RESOLUTION AUTHORIZING CHANGE ORDER NO. 2 FOR
ALBERTA REVITALIZATION INFRASTRUCTURE PHASE 1B
(A15-0388)

CONTRACT CHANGE ORDER NO. 2

DATE: January 8, 2016
PROJECT: ALBERTA REVITALIZATION INFRASTRUCTURE PROJECT PHASE 1B
TO: RYAN SHIRLEY COMPANY, INC. (Contractor)

**CHANGE
ORDER
REQUEST**

SIDE VIEW OF A
COV. IT CABINET
AND LGT POLE
V.S.

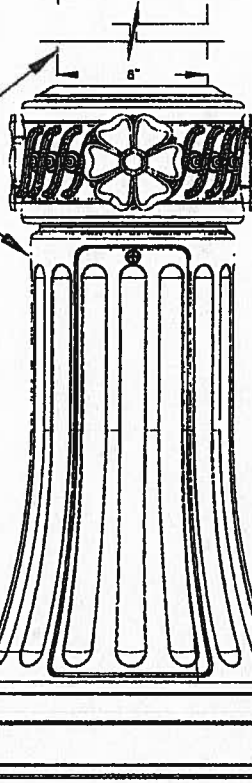
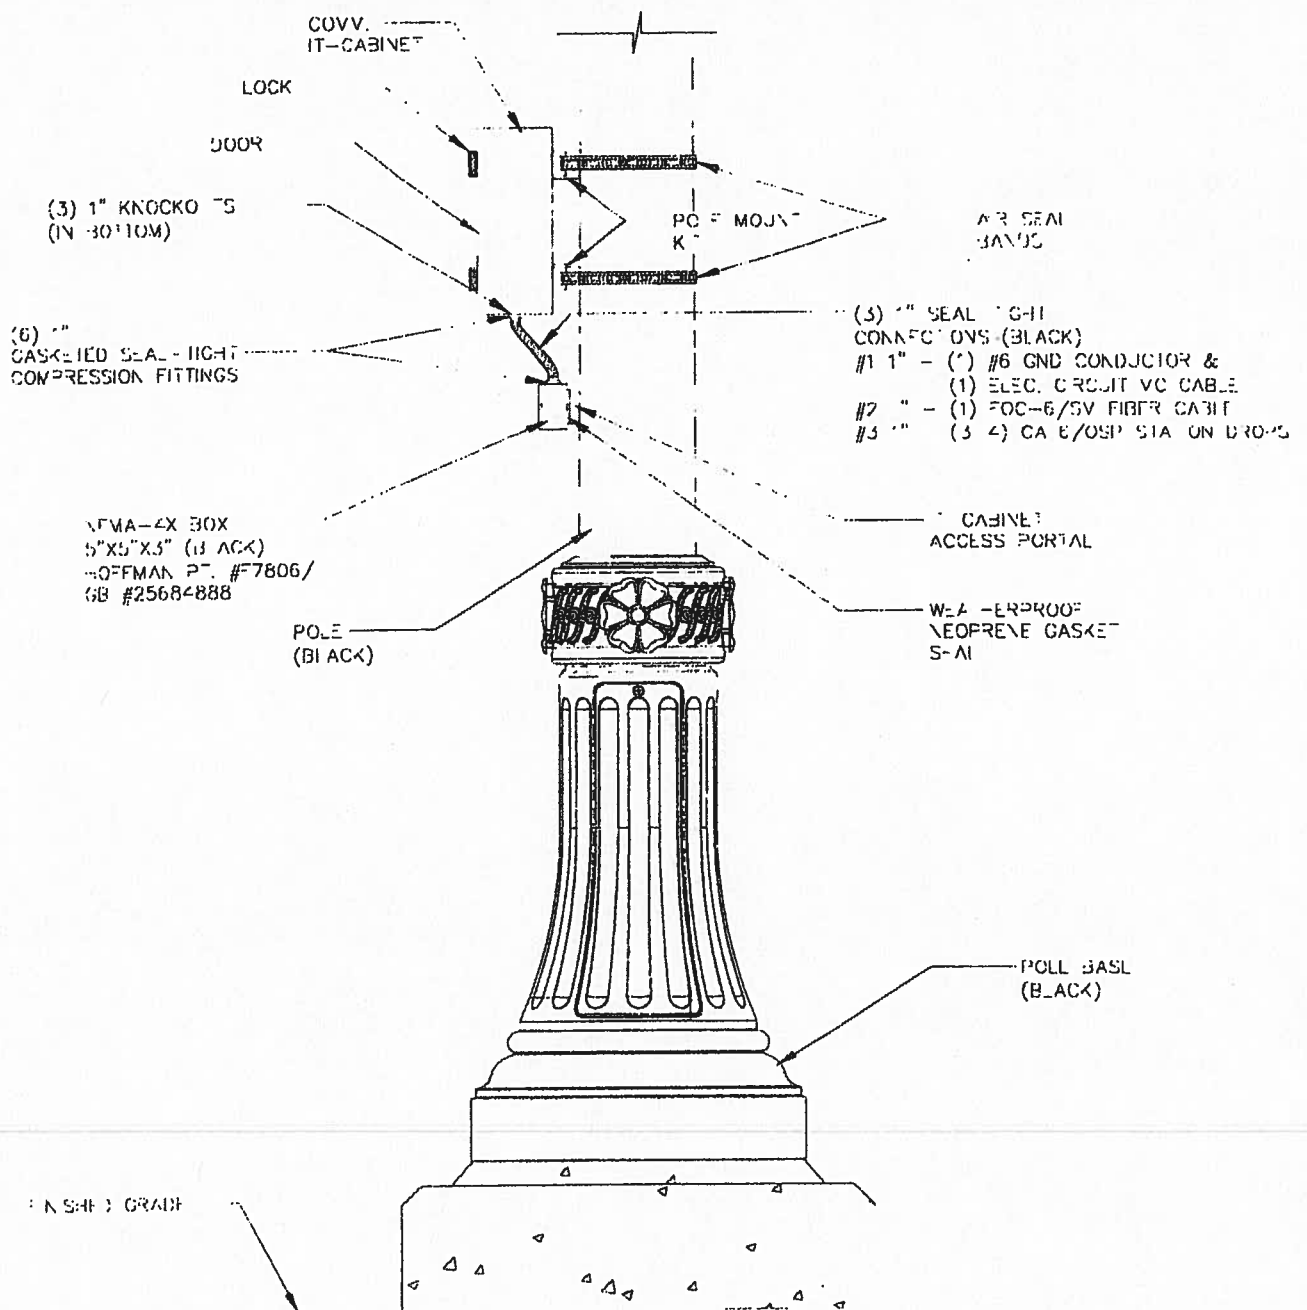
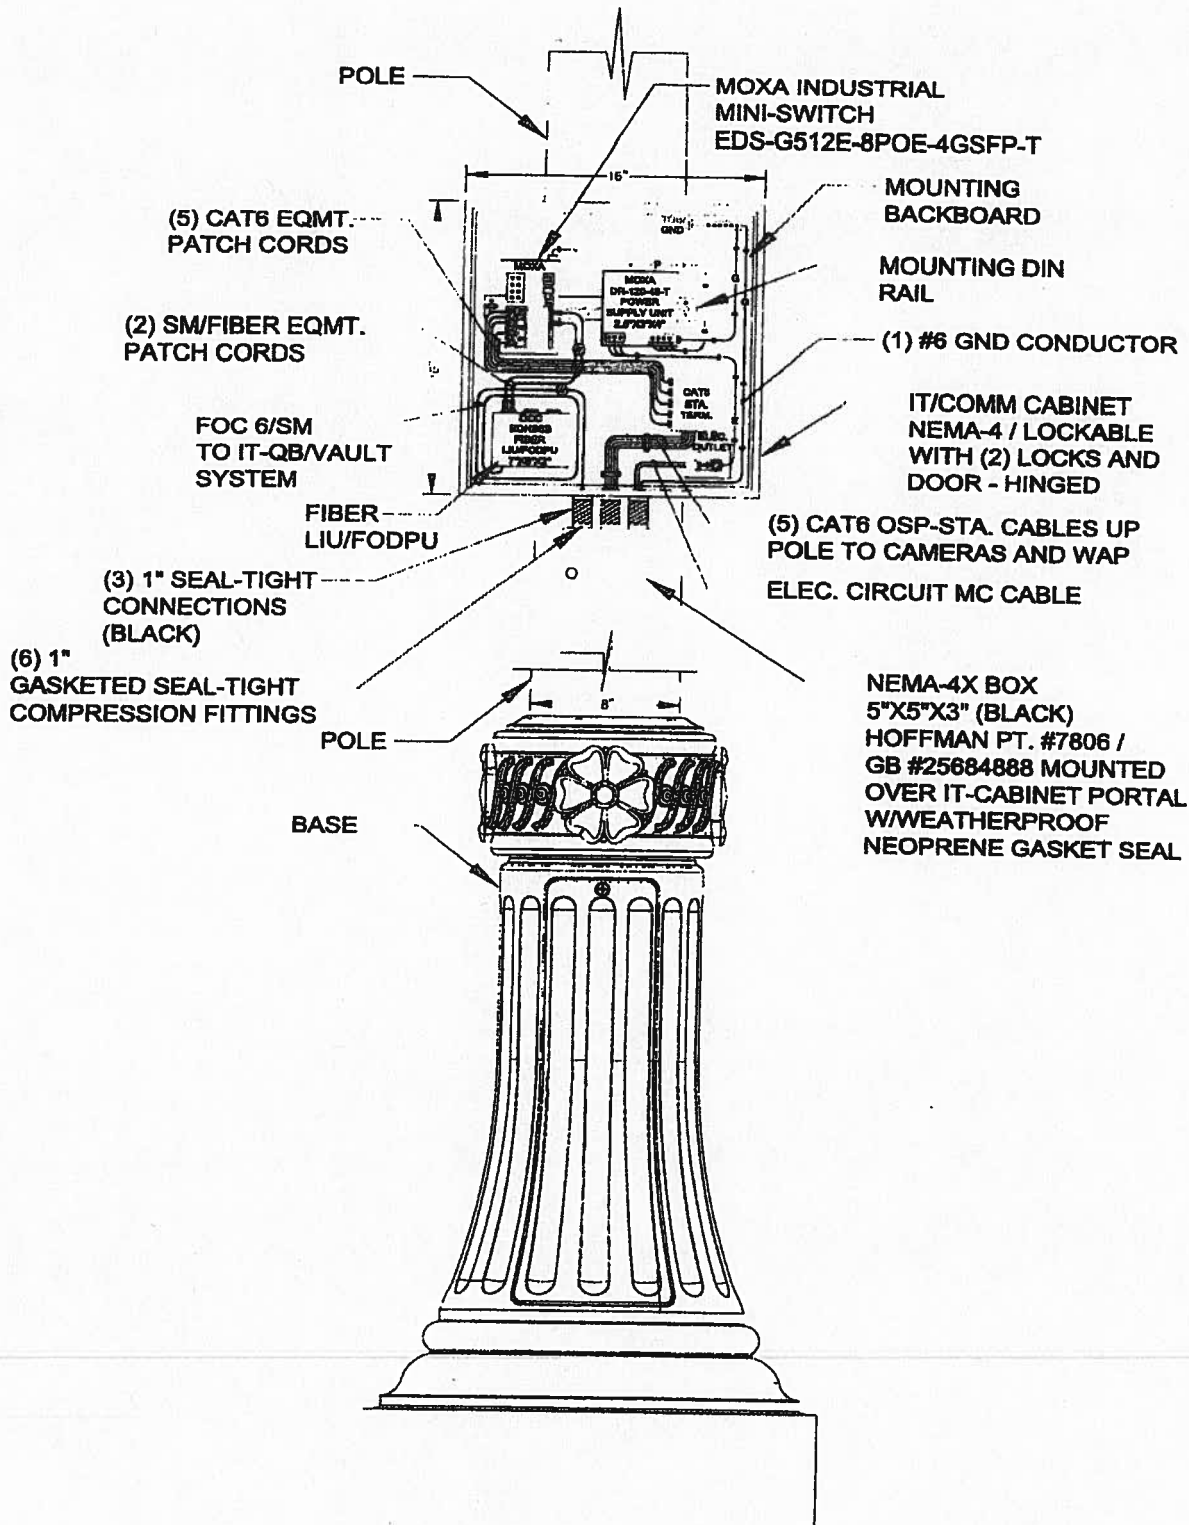
Work associated with this RFP includes the addition of (15) NEMA-4X 5"x5"x3" Black Boxes with Weatherproof Neoprene Gasket Seals. The intent of this box is to serve as an alternative to cutting an opening in the back of the IT cabinet but rather to allow for installation of the cables to be routed from the pole to enter into the bottom of the IT Cabinet. This is further illustrated on the attached sketches. These sketches and further detail requirements on the required material and installation methods can be found on the Memorandum from TALA Professional Services dated November 11, 2015, Item No. 2, and provided to you during the pole pre-installation meeting. This cost shall include all boxes, fittings, gasket seals, seal tight conduit, etc. required to complete the work as directed.

NEMA-4X BOX
5"X5"X3" (BLACK)
HOFFMAN PT. #7806 /
GB #25684888 MOUNTED
OVER IT-CABINET PORTAL
W/WEATHERPROOF
NEOPRENE GASKET SEAL

C3-1

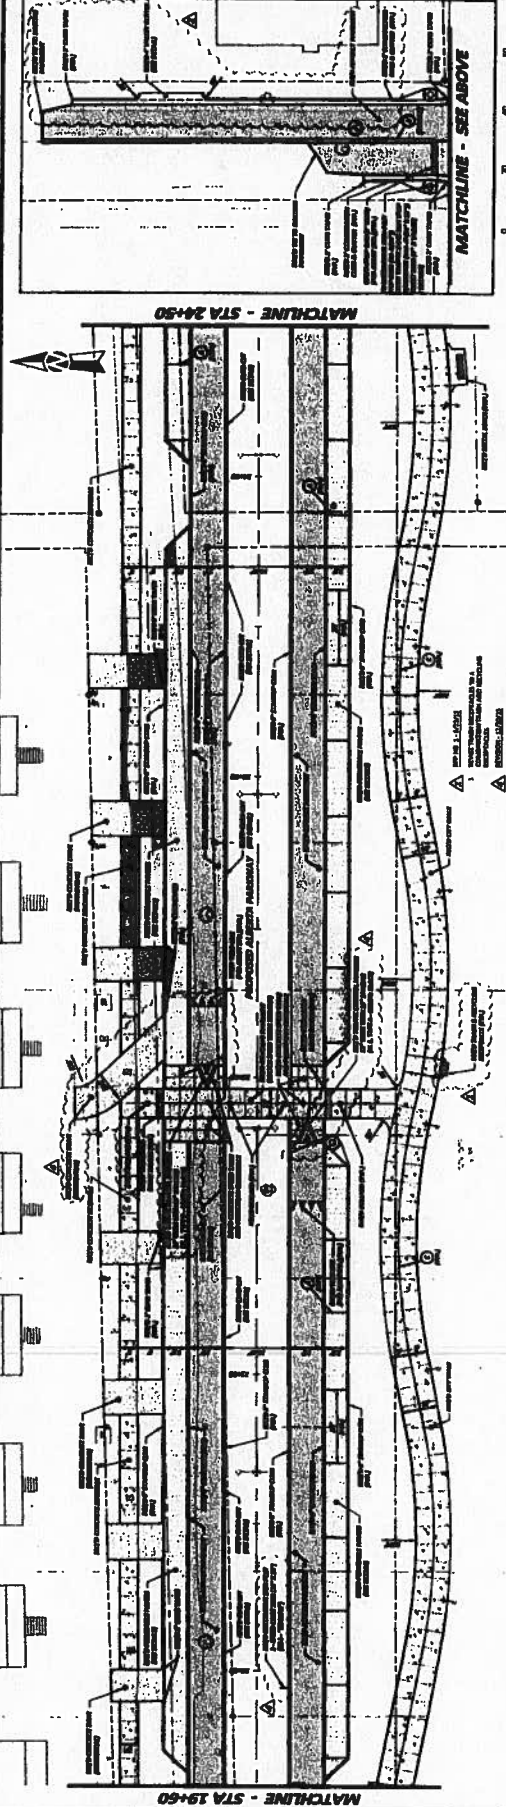
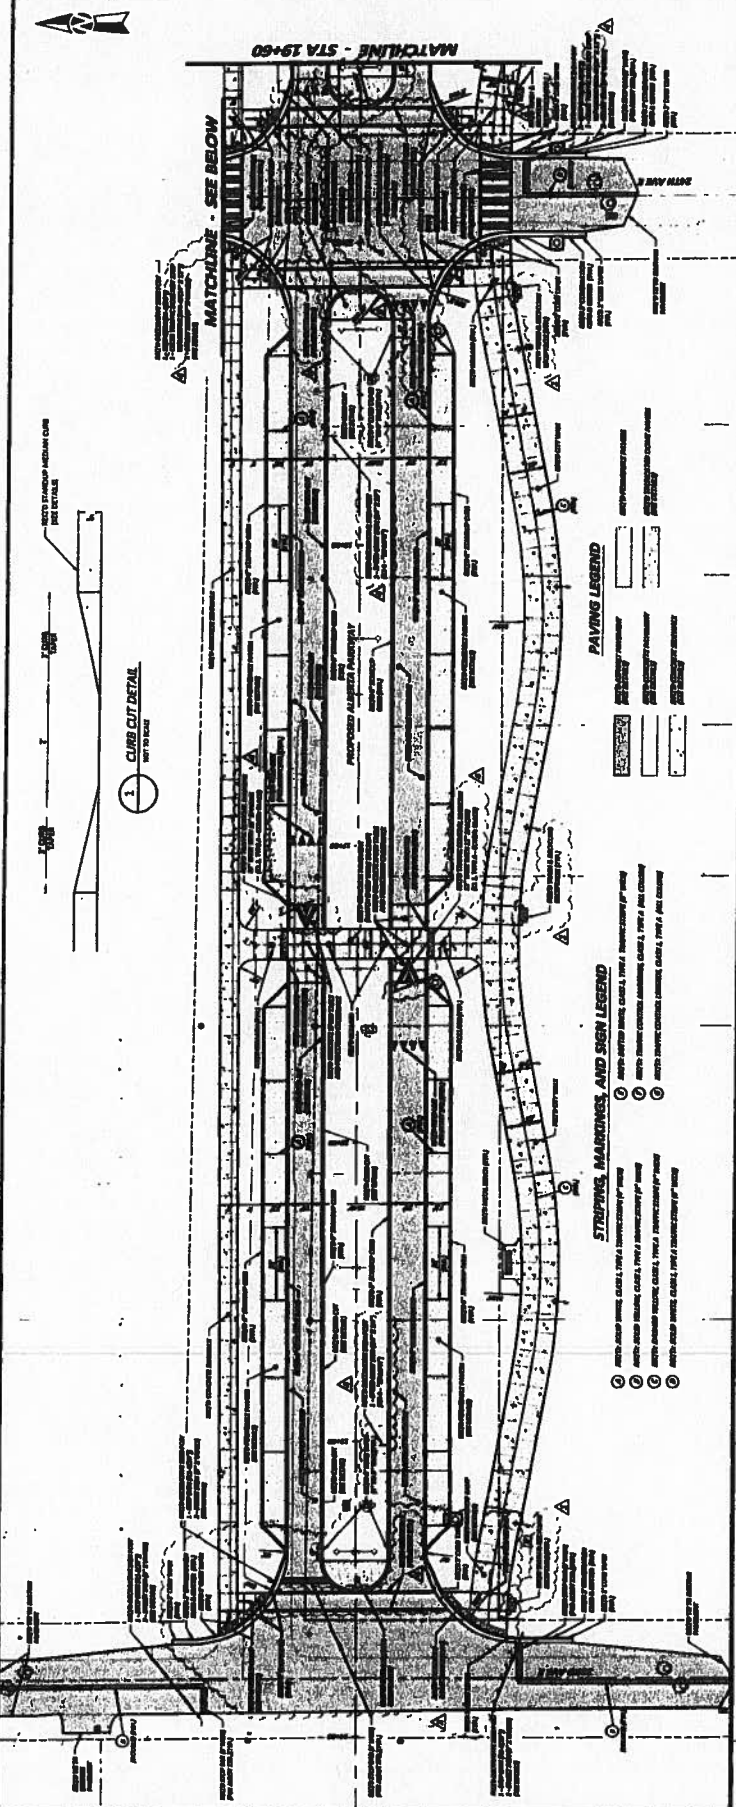
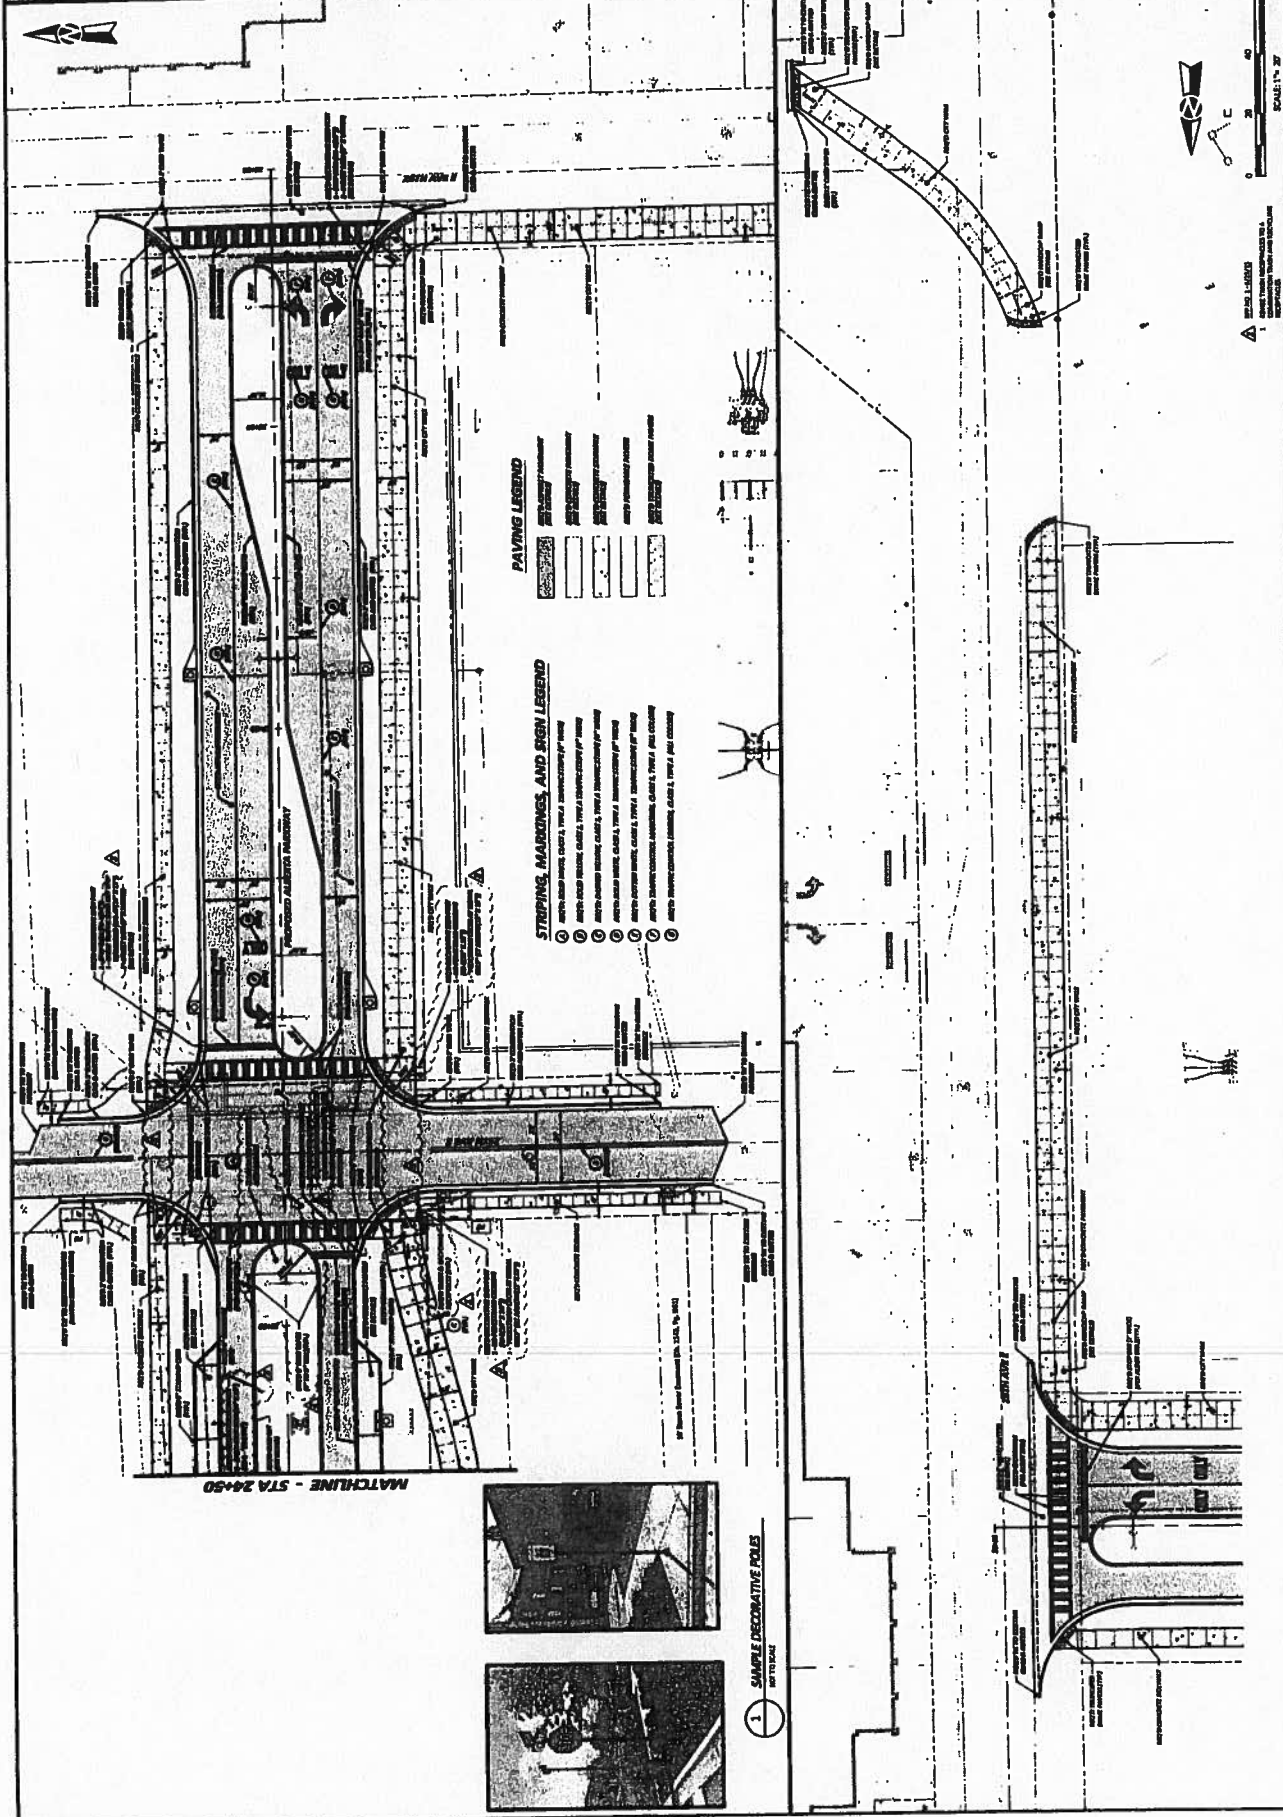
Please see attached revised plan sheets C3.1 and C3.2 and supplemental sign details. The attached drawings reflect revisions made on 12/30/15 to modify proposed roadway striping, roadway signing, and driveway layouts. Please provide pricing for the below listed additional items which were not included in the original bid.

Description:					
Item No.	Quantity	Unit	Description	Unit Cost	Total Cost
10B	4	each	Speed Limit Sign "20 MPH" (24" x 30" - R2-1) & Decorative Post	\$1,035.00	\$4,140.00
11B	2	each	"Yield To Pedestrian" Sign (R1-5L) and Decorative Post	\$1,035.00	\$2,070.00
12B	2	each	"No Pedestrian Crossing" (18" x 18" - R9-3) & "Pedestrian Cross at Signal Only" (12" x 18") Signs and Decorative Post	\$1,035.00	\$2,070.00
13B	4	each	"Cross Traffic Does Not Stop w/Arrows" (24" x 12" - W4-4P) Sign Only	\$225.00	\$900.00
				Total	\$9,180.00
